AGENDA
City of Gig Harbor Design Review Board
Virtual Meeting of June 8, 2023 at 5:00 pm

1. **City of Gig Harbor, 3510 Grandview Street, Gig Harbor, WA 98335: SKANSIE NETSHED CERTIFICATE OF APPROPRIATENESS: (PL-HR-23-0001)** The proposal is for the requested review for a Certificate of Appropriateness. The applicant has proposed rehabilitation work consisting of repainting, reroofing, and structural stabilization of the net shed. The site is located on the east side of Harborview Dr., at the intersection of Rosedale Street and Harborview Dr., along the bulkhead within the City of Gig Harbor, Skansie Park. Sec 08, Tw 21, R 02, Qtr 21. Parcel # 0221082232

PLANNING DEPARTMENT
STAFF REPORT

Sports Complex Phase 1B
PL-SPR-23-0001 et al
Design Review Board 04.27.2023
Exhibit A

SHEET
C-202

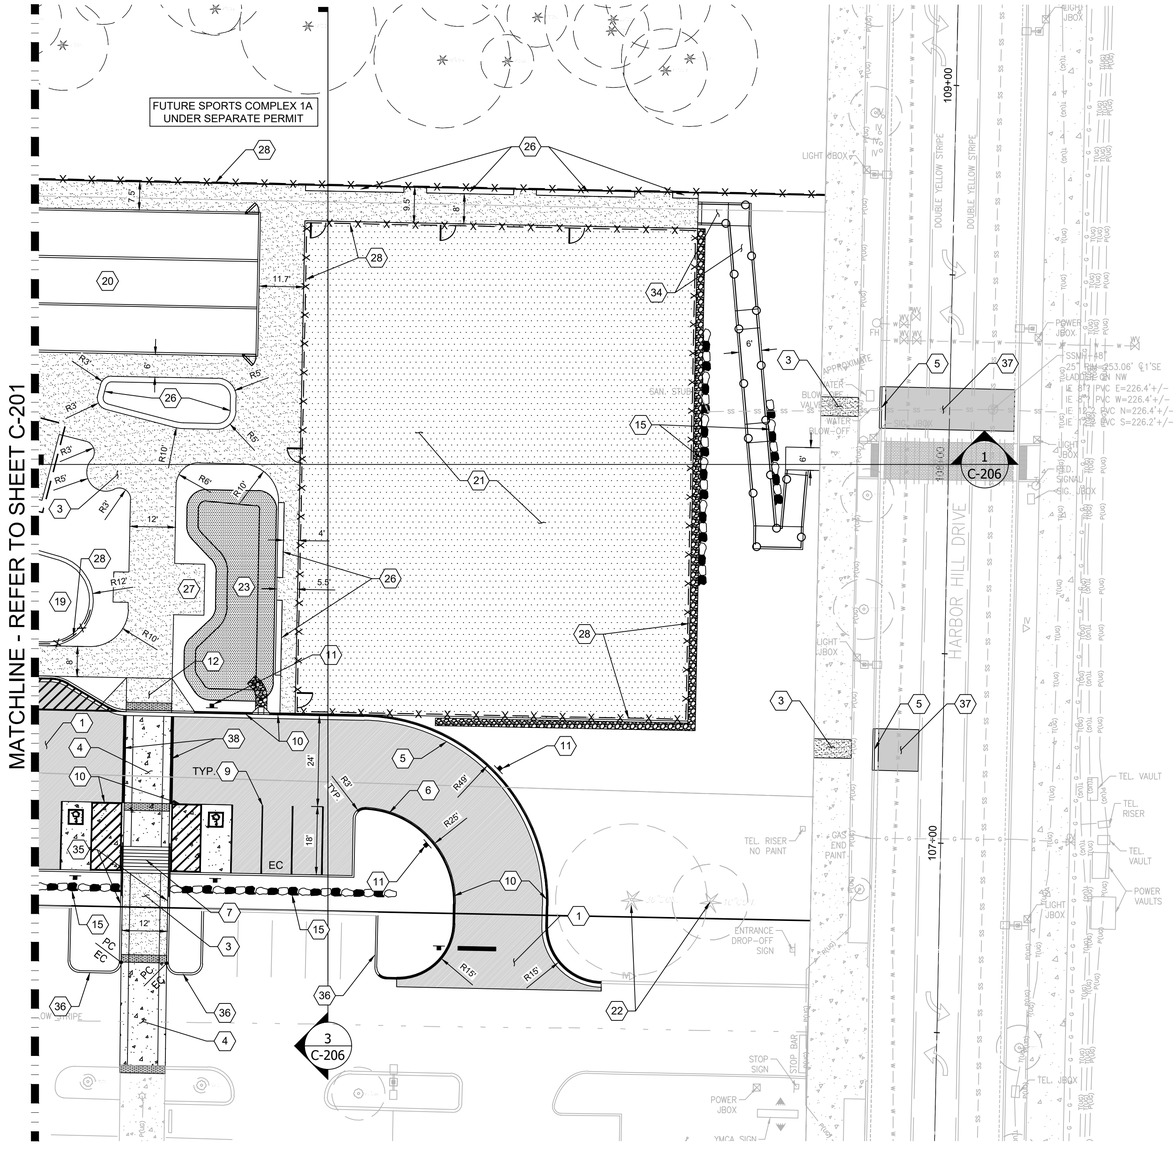
1. **Applicant's Request:** The applicant is requesting that the DRB review and recommend approval of an exception to include a fence that is not compliant with the Design Manual. The location of the fence is on Sheet C-202 and fence details are on sheet L-522 of the plan set (Exhibit A). The fence is chain link which is not permitted forward of the front setback line along a defined parkway (Harbor Hill Drive) according to GHMC 17.99.140.B.

The applicant's narrative describes the proposed design exception as consistent with the intent and general scope of the Design Manual; the chain link material is readily expected and accepted as part of recreational courts, the development encourages safe pedestrian usage, and the use of design elements which enhance public safety are justified by the Comprehensive Plan.

The requested design exception is sufficiently compensated by the use of black vinyl coating on the chain link. The proposed development will be a community amenity and provide much-needed capacity for recreational team sports.

<u>MOTION:</u> Move to approve with conditions that the development of the parcel has been designed in a manner that is consistent with the character of the area and that the proposed Design Exception is found to be consistent with the intent of the general scope with the conditions that the upper pile wall utilize cascading landscaping on the upper portion of the wall to help mitigate the height of the wall as well as the Arborvitae plants with a size smaller than 6 ft initially at the base of the wall to help screen the wall. Filand / Ashlock.

2 4' CHAINLINK FENCE

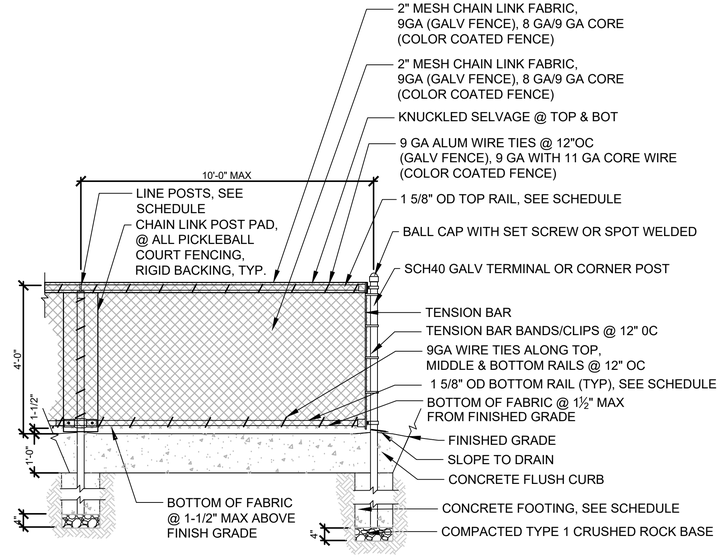
The proposed project includes a fence that is not in compliance with the design manual. Please reference the location of the fence on sheet C-202, number 28 and fence details on sheet L-522.
